# UNITED STATES PATENT AND TRADEMARK OFFICE

10/785,265

<b>Office Action Summary</b>	<b>Application No.</b>	<b>Applicant(s)</b>	
	10/785,265	BURI ET AL.	
	<b>Examiner</b>	<b>Art Unit</b>	
	Evan H. Langdon	3654

## **DETAILED ACTION**

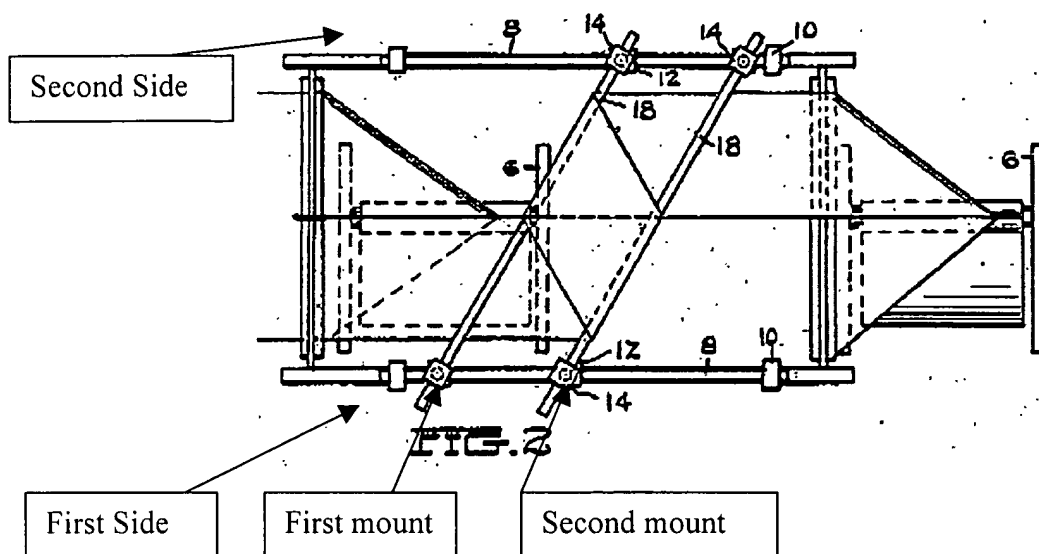
In regards to claims 19-22, Hamlin discloses the turning bars 18 can be removed from the mounts 12 while the mounts are adjusted along the guide 8, the reconnected. Hamlin discloses two mounts 12 on a first side and two mounts on a second side (Fig. 2), but fails to disclose the first turning bar attached to the second mount.

It would have been obvious to one of ordinary skill in the art at the time the invention was made to insert the first turning bar of Hamlin in the second mount on the same respective side to provide more arrangements of the turning bars (see below).
